# Issue with 50G PAM4 C2M Specification

**IEEE 802.3bs Electrical Adhoc Meeting**

**Jan 23rd, 2017**

# Crosstalk for C2M Test Case 3 and 5

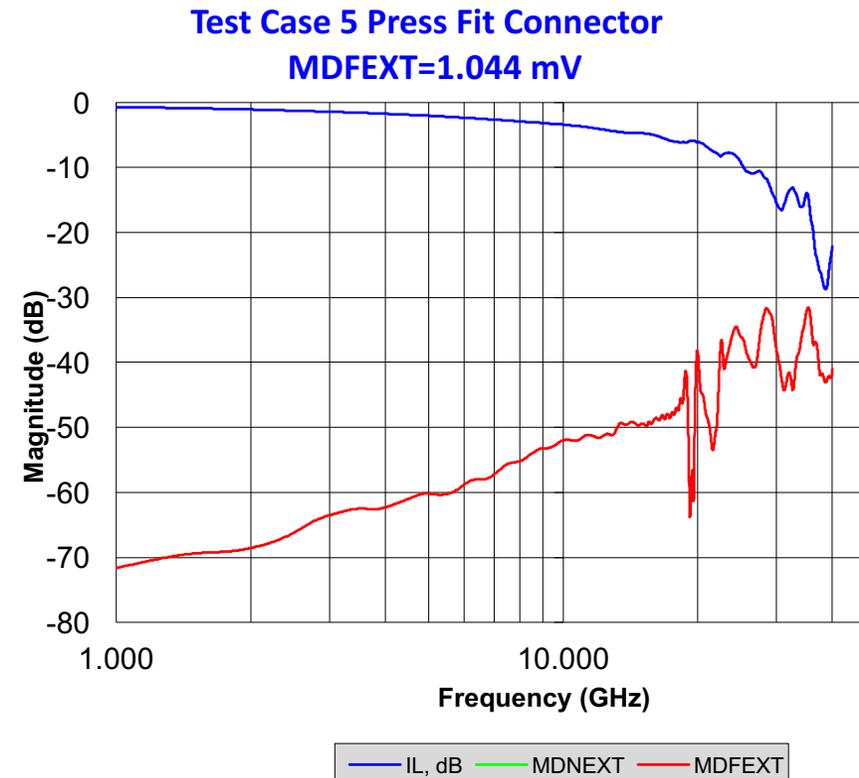
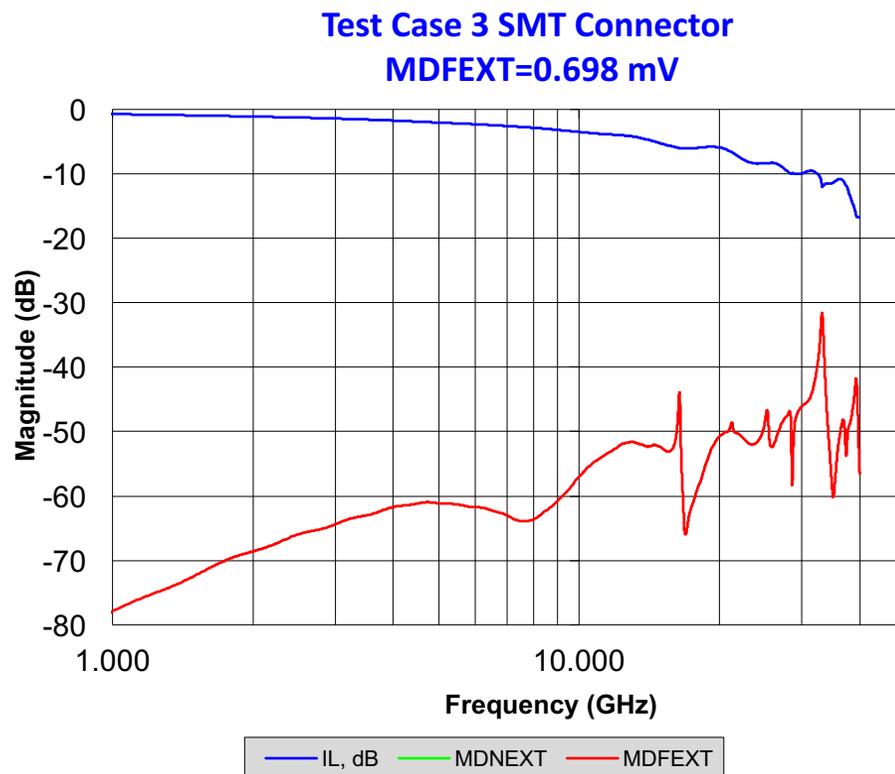
## ☐ Mated board had no NEXT and with excellent FEXT

- [http://www.ieee802.org/3/bs/public/channel/TEC/shanbhag\\_3bs\\_01\\_1014.pdf](http://www.ieee802.org/3/bs/public/channel/TEC/shanbhag_3bs_01_1014.pdf)
- C2M are based on channels with 5-7x lower crosstalk than mated board referenced currently!

# Results with MTF Test Board

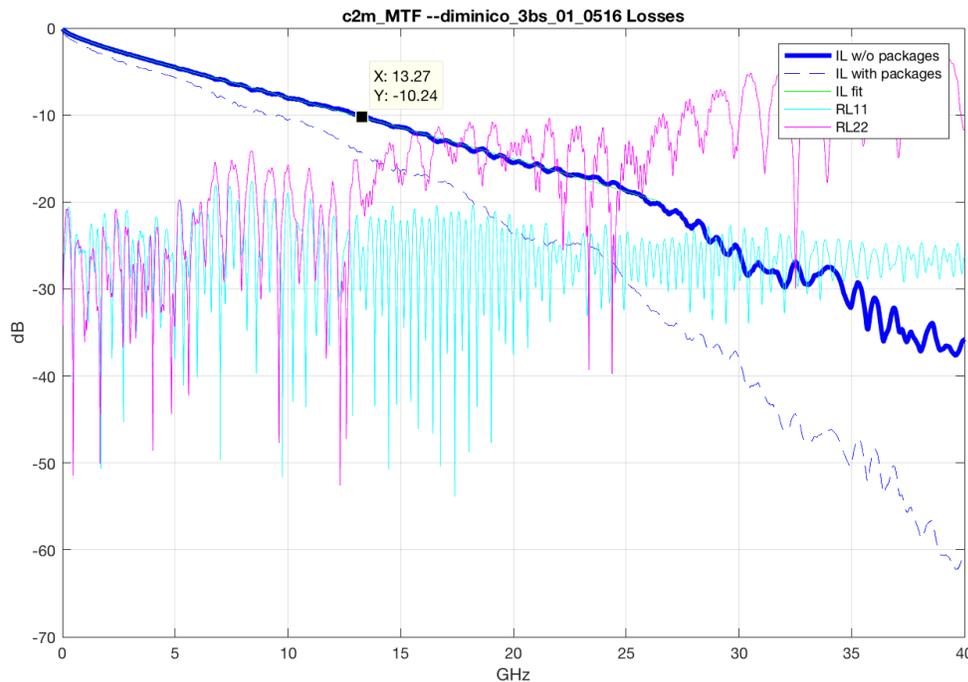
□ TP1a response of the MTF test board + 150 mm trace has output VEO=32.2 mV without any crosstalk just passes the limit in CL 120.E!

VEO=32.2 mV, ICN=0 mV, Peak ISI=10.8 mV, MDFEXT Peak=0 mV

COM=5.13 dB

# 4" TE Stacked 50G Channel Meeting MTF

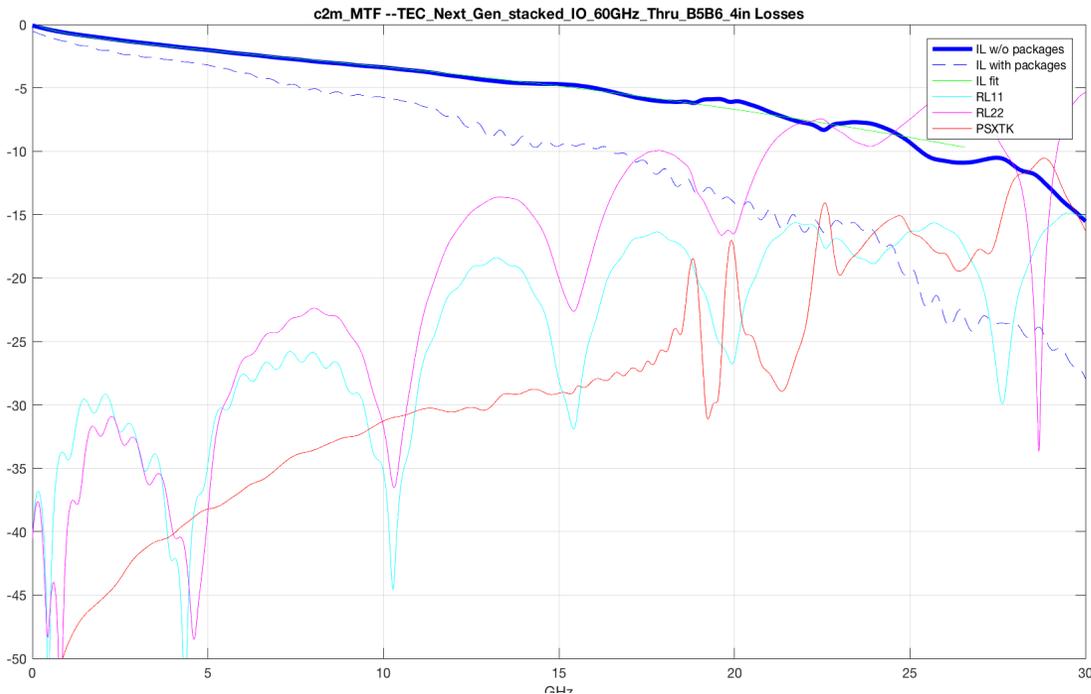
- Based on TE hypothetical connector with IL\_Fit of 4.3 dB but having MDFEXT p-p=2.37 mV (MDFEXT RMS for BER 1E-5=2.37/4.26=0.56 mV)
  - To account for worst case MDFEXT=4.8 mV and MDNEXT=1.8 mV (PSXT=5.13 mV RMS) A\_fe in in COM was adjusted from 0.45 to 4.12 in order to get MDFEXT p-p of 21.84 mV equivalent to PSXT of 5.13 mV RMS per table 92-13
  - [http://www.ieee802.org/3/bs/public/channel/TEC/shanbhag\\_3bs\\_01\\_1014.pdf](http://www.ieee802.org/3/bs/public/channel/TEC/shanbhag_3bs_01_1014.pdf)

VEO=58 mV, ICN=1.237 mV, Peak ISI=21.5 mV, MDFEXT Peak=2.37 mV

COM=5.01 dB

VEO=42.5 mV, ICN=1.237 mV, Peak ISI=21.5 mV, MDFEXT Peak=21.88

mV COM=3.36 dB

# 10" TE Stacked 50G Channel

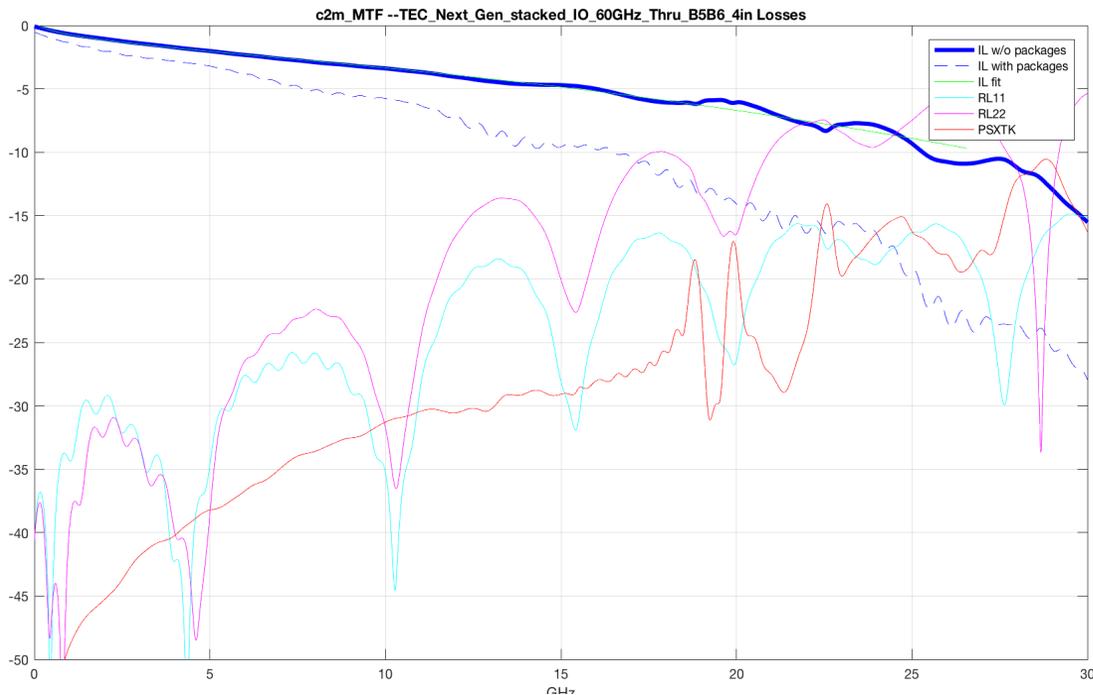
Based on TE hypothetical connector with IL\_Fit of 8.8 dB shy of clause 120.E loss of 10.2 dB

- Since the 4" and 10" TE stack boards have similar construction with exception of one with longer trace, the calibrated  $A_{fe}$  crosstalk of the 4" board is used for the 10" board
- [http://www.ieee802.org/3/bs/public/channel/TEC/shanbhag\\_3bs\\_01\\_1014.pdf](http://www.ieee802.org/3/bs/public/channel/TEC/shanbhag_3bs_01_1014.pdf)

VEO=28.2 mV (failing), ICN=0.759 mV, Peak ISI=11.55 mV, MDFEXT

Peak=12.89 mV COM=3.65 dB

# 10" TE Stacked 50G Channel

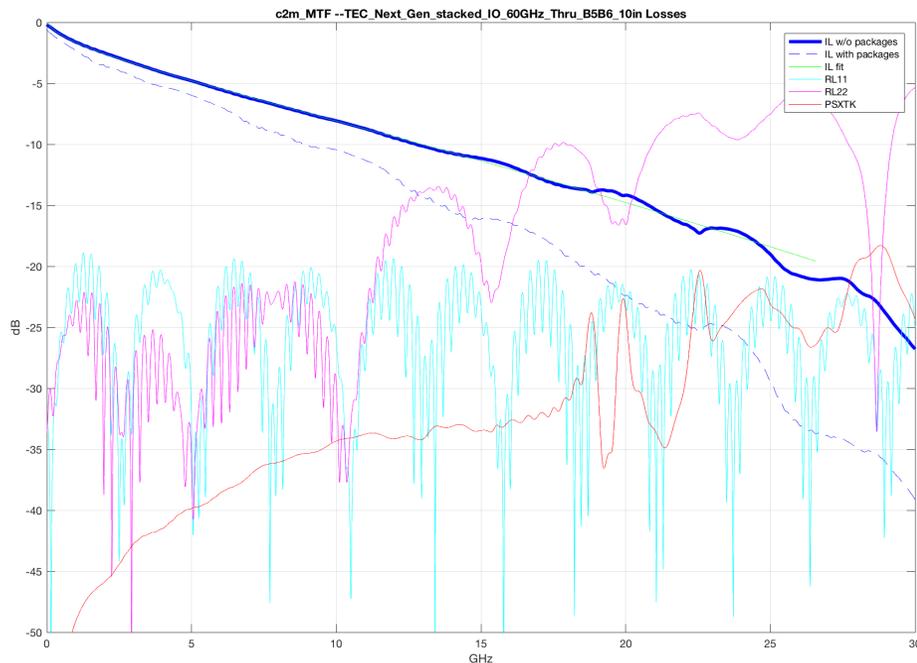
- Based on TE hypothetical connector with IL\_Fit of 8.8 dB shy of clause 120.E loss of 10.2 dB, to increase the loss to 31 mm of PCB trace per clause 120 is added
  - Since the 4" and 10" board are similar with exception of the longer trace, calibrated  $A_{fe}$  crosstalk is kept at 4.14 for the 10" board+31 mm PCB trace

Using COM version 165  
Results with  $A_{fe}=4.14$ :  
**VEO=21.2 mV (failing)**, ICN=0.759 mV, Peak ISI=11.38 mV, MDFEXT  
Peak=12.84 mV, COM=3.03 dB

# QSFP MTF + Crosstalk from TE 4" Stacked

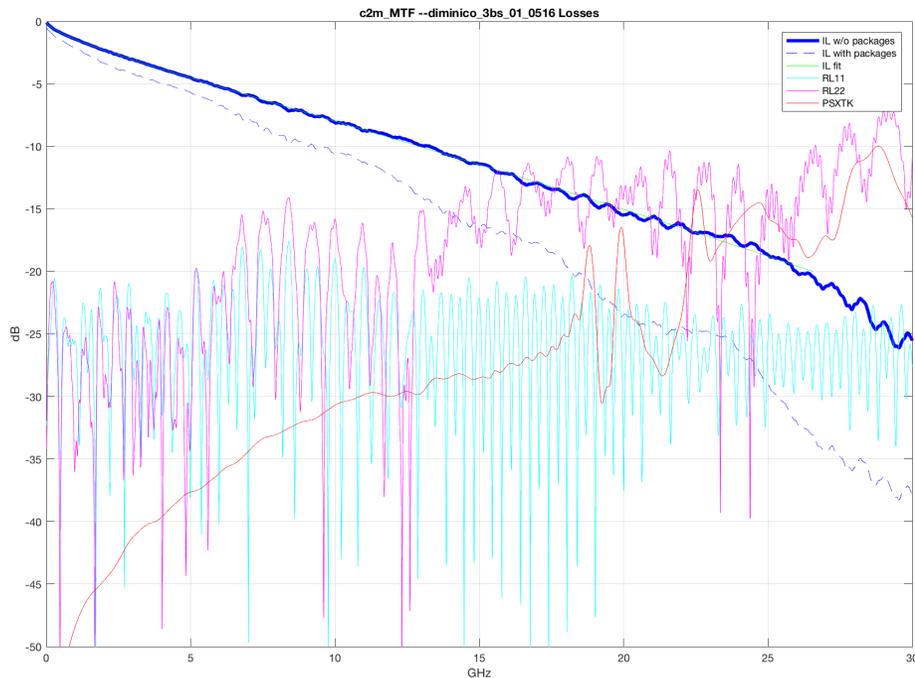
- ❑ QSFP MTF (diminico\_3bs\_01\_0516.s4p) does not have any crosstalk data
  - TE 4" stacked with IL\_Fit of  $\approx 4.3$  is used as the crosstalk source
  - 150 mm of PCB trace is added per clause 92 to increase the loss to 10.2 dB
  - The calibrated crosstalk source is  $A_{fe}=4.14$

**VEO=10.9 mV (failing)**, ICN=1.237 mV, Peak ISI=10.7 mV, MDFEXT Peak=20.87 mV COM=1.43 dB
